Model: LCT for AD1-E		Date: 15-Feb-98	No: 1
Modified Article: Timing Pulley		Prepared by: K. Ugaeri	
From: QAC Field Information Dept.			
Reason for Modification:	<input checked="" type="checkbox"/> Parts catalog correction	<input type="checkbox"/> Vendor change	<input type="checkbox"/> To meet standards
	<input checked="" type="checkbox"/> To facilitate assembly	<input checked="" type="checkbox"/> To improve reliability	()
	<input checked="" type="checkbox"/> Part standardization	<input type="checkbox"/> Other

Reissue date: **15-Jun-98**

Model: LCT for AD1-E		Date: 15-Feb-98	No: 1A
Modified Article: Timing Pulley		Prepared by: K.Ugaeri	
From: QAC Field Information Dept.			
Reason for Modification:	<input checked="" type="checkbox"/> Parts catalog correction	<input type="checkbox"/> Vendor change	<input type="checkbox"/> To meet standards
	<input checked="" type="checkbox"/> To facilitate assembly	<input checked="" type="checkbox"/> To improve reliability	()
	<input checked="" type="checkbox"/> Part standardization	<input type="checkbox"/> Other

3.LCT UNIT 3 (A667)

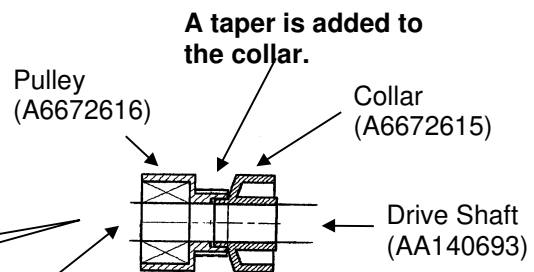
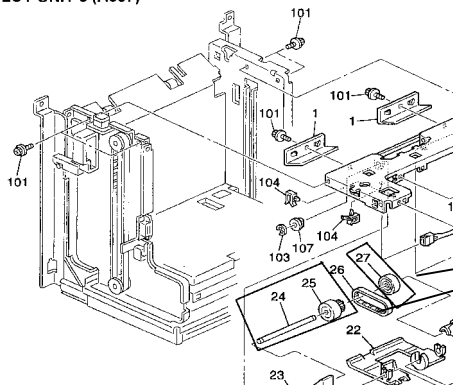
A.To reduce paper jams caused by dust between the timing pulley and the drive shaft :

| 1. AA140627(1) • AA140693(1) | Drive Shaft – Feed Roller | } X/O | P 7-24 |
| 2. H5194713(1) • A6672615(1) | Timing Pulley Collar – 6x8 | | P 7-27 |
| 3. H5194714(1) • A6672616(1) | Timing Pulley – 22Z | | P 7-25 |

The collar has been made so that a portion of it is inserted into the pulley.

5.LCT UNIT 5 (A667)

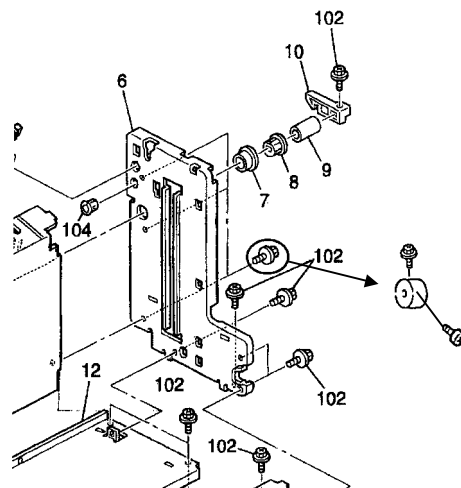
B.To reduce the noise from the relay roller :

| 1. AF020385(1) → AF020452(1) → Relay Roller | } X/O | P11-16 |
| 2. A6672516(1) Fly Wheel (New) | | |
| 3. 03140060W(2) Philips Pan Head Screw-M4x6 (New) | | |

3.LCT UNIT 3 (A667)

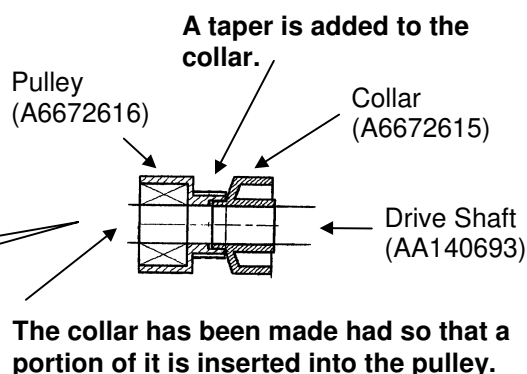
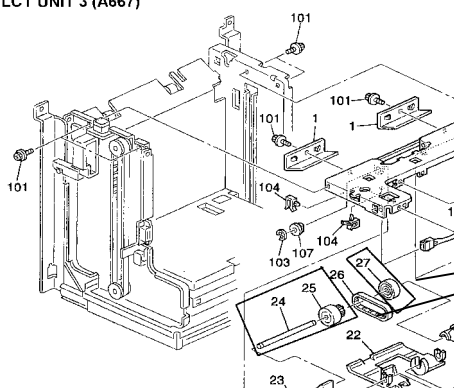
The illustration has changed as shown below.

A. To reduce paper jams caused by dust between the timing pulley and drive shaft :

| 1. AA140627(1) • AA140693(1) | Drive Shaft – Feed Roller | } X/O | P 7-24 |
| 2. H5194713(1) • A6672615(1) | Timing Pulley Collar – 6x8 | | P 7-27 |
| 3. H5194714(1) • A6672616(1) | Timing Pulley – 22Z | | P 7-25 |
